**STAFF RECOMMENDATION**  
**1901 Russell Street**  
**May 20, 2020**

**Application:** New Construction—Infill  
**District:** Lockeland Springs-East End Neighborhood Conservation Zoning Overlay  
**Council District:** 06  
**Base Zoning:** R6  
**Map and Parcel Number:** 083140099  
**Applicant:** Jason Feller  
**Project Lead:** Jenny Warren [jenny.warren@nashville.gov](mailto:jenny.warren@nashville.gov)

<p><b>Description of Project:</b> Construct infill house to replace house demolished after the March 3, 2020 tornado.</p> <p><b>Recommendation Summary:</b> Staff recommends approval of the project with the following conditions:</p> <ol style="list-style-type: none"><li>1. The finished floor height be consistent with the finished floor heights of the adjacent historic houses, to be verified by MHZC staff in the field;</li><li>2. Staff approve the final materials, including doors, windows, roofing color, brick, porch post materials and walkway material;</li><li>3. A front walkway shall be added from the house to the sidewalk on Russell Street, and</li><li>4. The HVAC be located behind the house or on either side, beyond the mid-point of the house.</li></ol> <p>With these conditio

Figure 2. 1901 Russell after the tornado

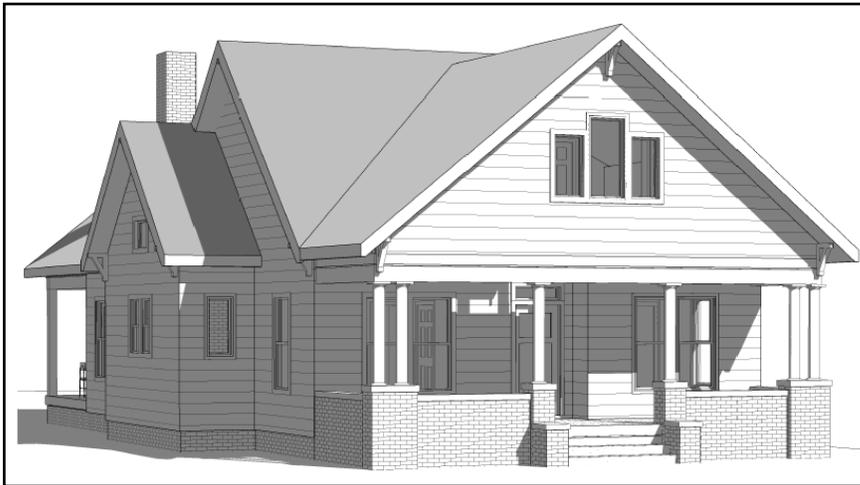
**Background:** 1901 Russell Street sits at the corner of 19<sup>th</sup> and Russell Streets. The contributing historic bungalow on this lot was severely damaged in the March 3, 2020 tornado. The house was considered a total loss, and MHZC staff issued an emergency demolition permit under the Rules of Order and Procedure VI.C.2.c, which allow for administrative issuance of demo permits for any structure that has become a major life-safety hazard. The lot is now vacant. See Figures 1-3.

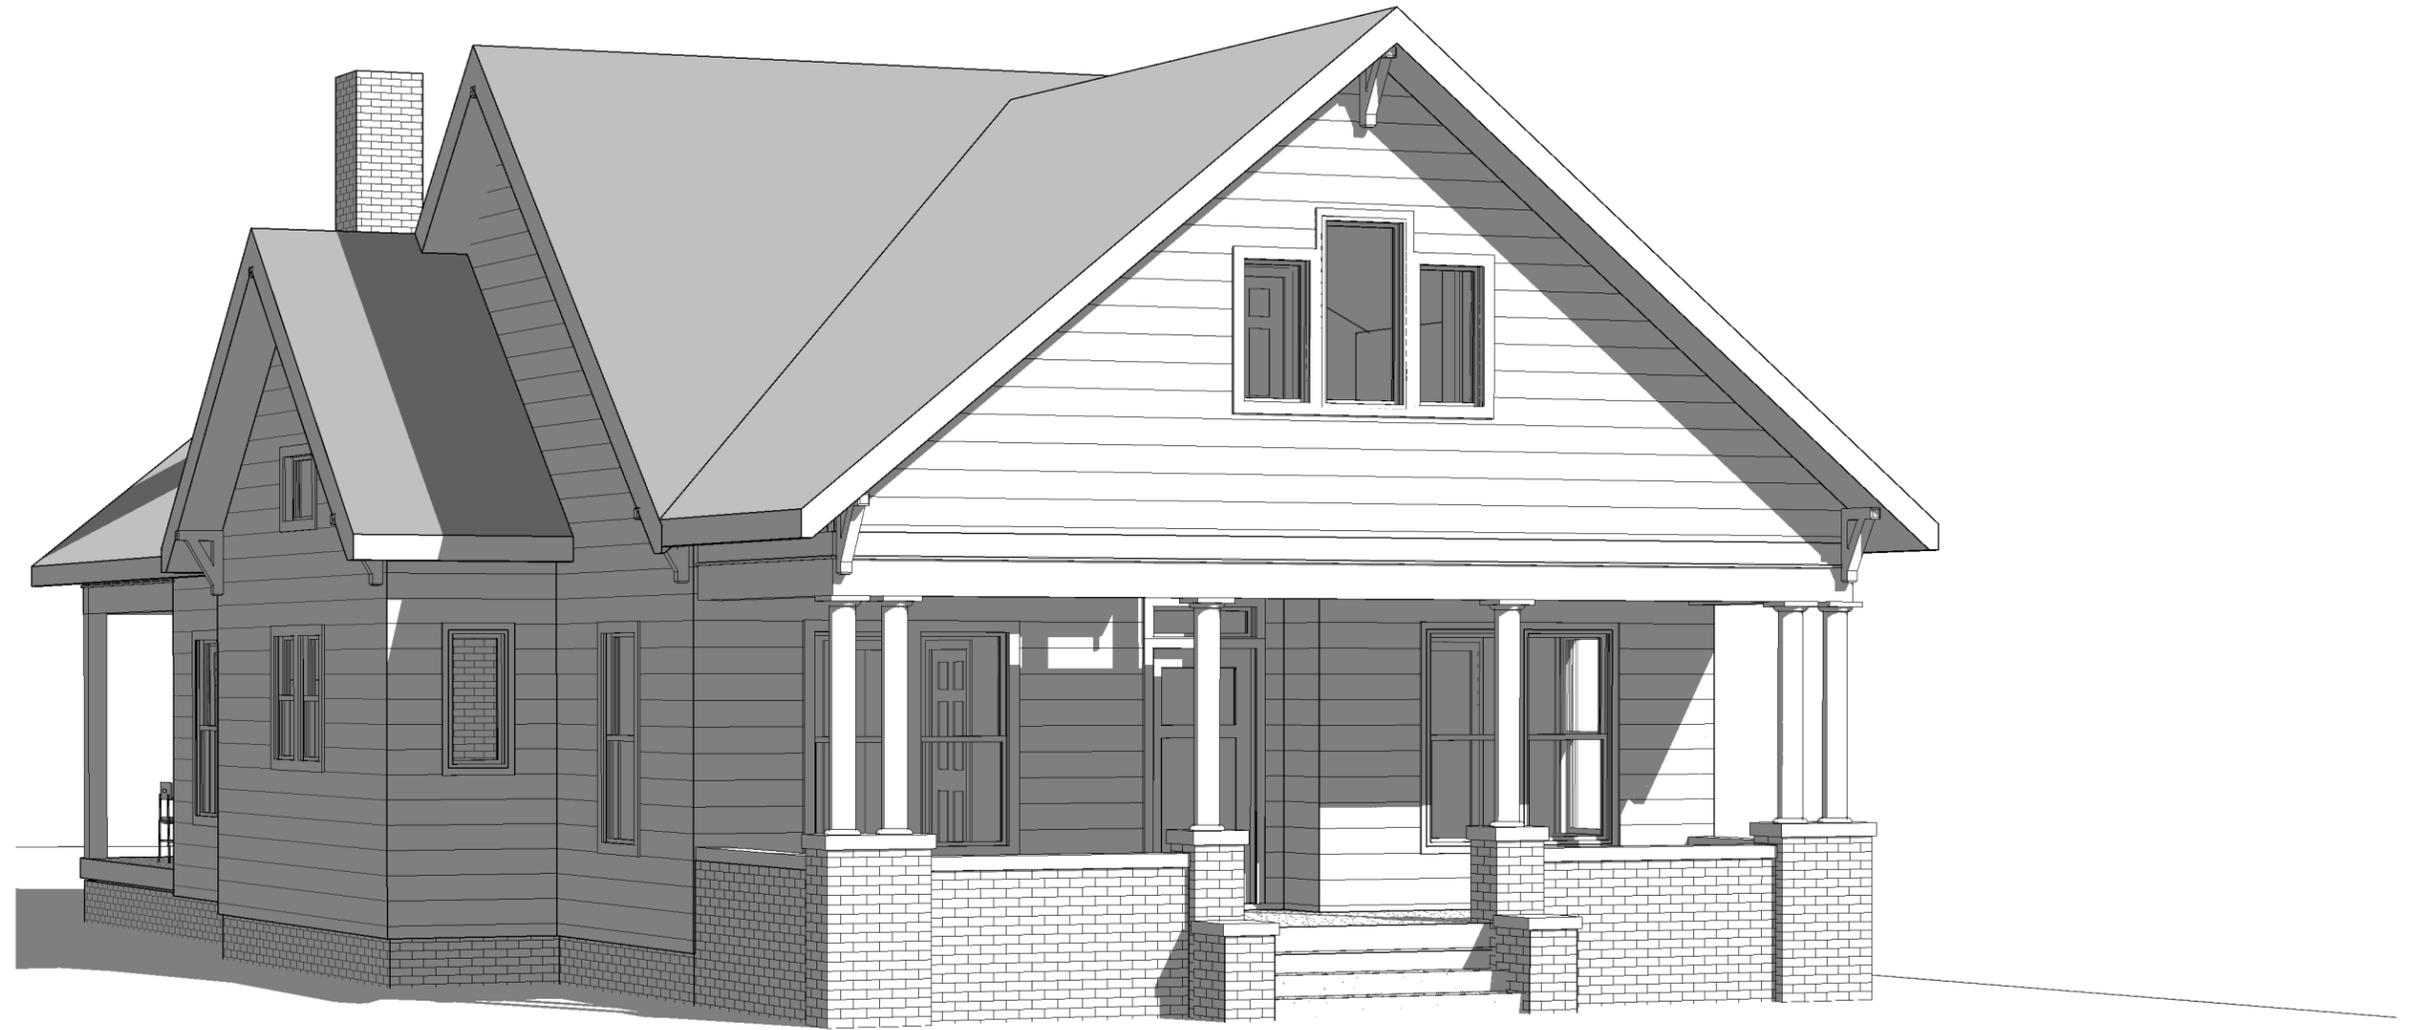
**Analysis and Findings:** The proposal is for a one-and-a-half story single-family house on the now-vacant lot.

The proposed infill is a one-and-a-half story house with a maximum height of about 25'6" (twenty-five feet, six inches) from grade. Surrounding historic houses on

comparably sized lots are one or one-and-a-half stories and between about twenty-two to twenty-six feet (22'-26') tall. Staff finds that the proposed infill is appropriate in terms of height and form.

The foundation is about two feet (2') high, which is appropriate for the context. As always with infill, staff should verify in the field that the finished floor height is consistent with the historic context.

The front elevation and the full width front porch are just over twenty-eight feet (28') wide. Both side elevations include a bay that bumps out wider, such that the maximum width of the house becomes thirty-four feet (34') wide. The historic context includes houses that range from about twenty-six to thirty-four feet (26'-34') wide. Staff finds that the proposed infill is appropriate in terms of width.

2 H - Left  
1/8" = 1'-0"

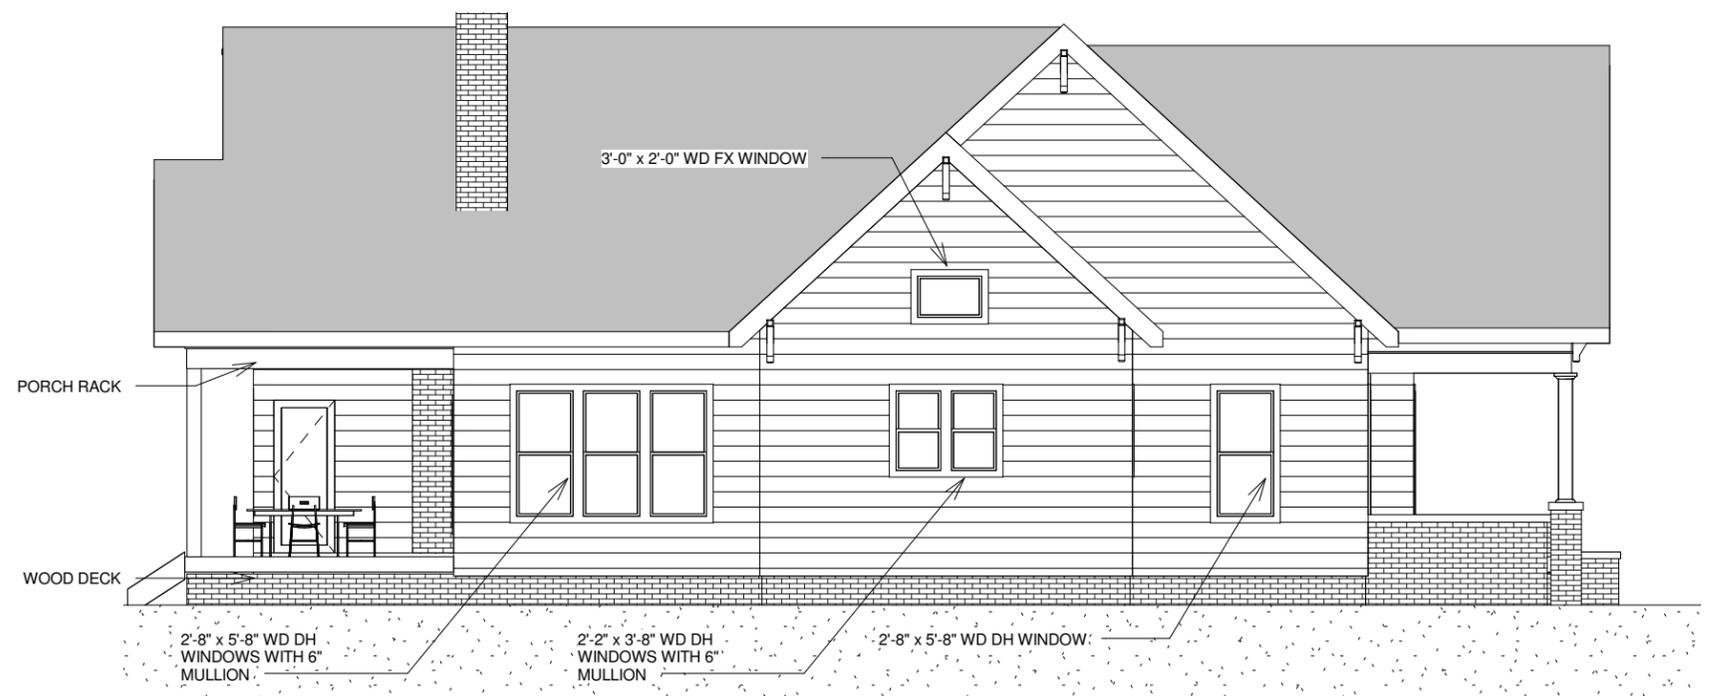
The proposed house will be about sixty feet (60') deep and will be articulated along the side-street elevation by the use of a five by sixteen foot (5'x16') bay. A covered porch is proposed on both the front and the rear.

**Proportion and Rhythm of Openings:** The primary windows on the proposed infill are all generally twice as tall as they are wide. thereby meeting the historic proportions of openings. The exceptions are three smaller horizontal windows along the side elevations. Staff finds these windows could be appropriate as they are accent windows used sparingly and are mostly confined to beyond the midpoint on the interior side elevation. There are no large expanses of wall space without a window or door opening.

Staff finds the infill's proportion and rhythm of openings to meet Section II.B.7. of the design guidelines.

1 Site Plan - Historic  
1/16" = 1'-0"

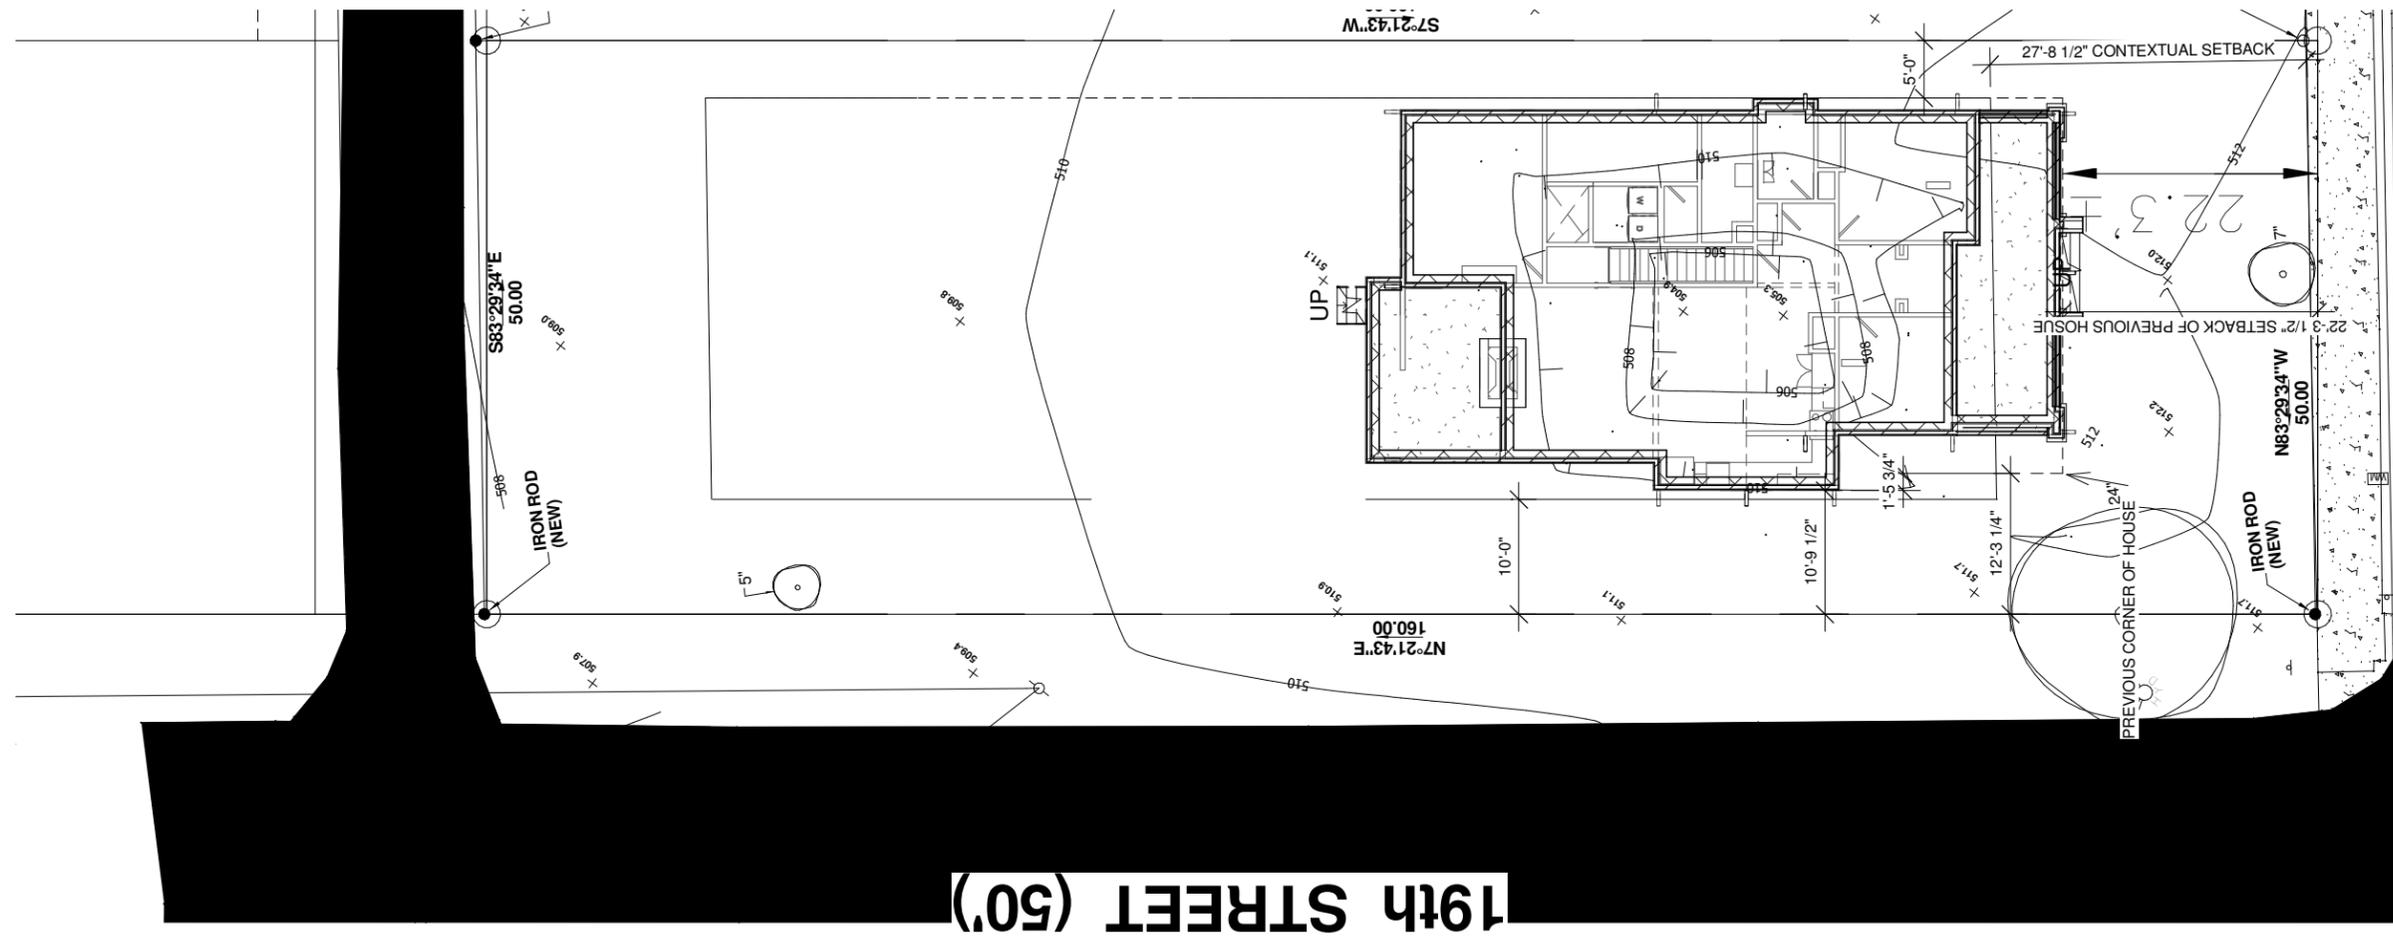
The front setback is proposed at about twenty-two feet (22') from the front property line. This is stepped slightly forward of the other houses in the immediate context, which staff finds appropriate in this specific instance for several reasons. First, this matches the setback of the historic house (Figure 6), so this would not create a new, inappropriate configuration. Second, although it steps several feet forward of the houses to its right, this is a corner lot and the houses across 19<sup>th</sup> Street have slightly shallower setbacks. Lastly, the proposed house, like its historic predecessor, has a full width front porch, such that the front six feet+ (6'+) of the house is covered porch. The solid front wall of the house will roughly align with the solid front walls of the houses along the block that have partial front porches.

On the right, the house will be five feet (5') from the interior side property line, at the closest point, where a one by six foot (1'x6') bay projects. On the street-facing side elevation, the house will sit about ten feet, nine inches (10'9") from the property line at the closest point. This positions the house a few feet closer to the property line than the historic house was. Staff finds this to be appropriate as the house will still be more than ten feet (10') from the side property line. The property line itself sits about eight feet, six inches (8'6") from 19<sup>th</sup> Street, so the distance to the street itself will be about nineteen feet (19'), which staff finds to be appropriate and consistent with the historic context.

The rear of the house will be more than seventy feet (70') from the rear property line.

The house will be oriented to Russell Street. It will have a full-width covered front porch, like its historic predecessor. The porch is a minimum of six feet (6') deep. No walkway to the front sidewalk is indicated, but one should be provided.

Staff finds that with the addition of a front walkway to the sidewalk, the infill's orientation will meet Section II.B.6. of the design guidelines.

1. The finished floor height be consistent with the finished floor heights of the adjacent historic houses, to be verified by MHZC staff in the field;
2. Staff approve the final materials, including doors, windows, roofing color, brick, porch post materials and walkway material;
3. A front walkway shall be added from the house to the sidewalk on Russell Street, and
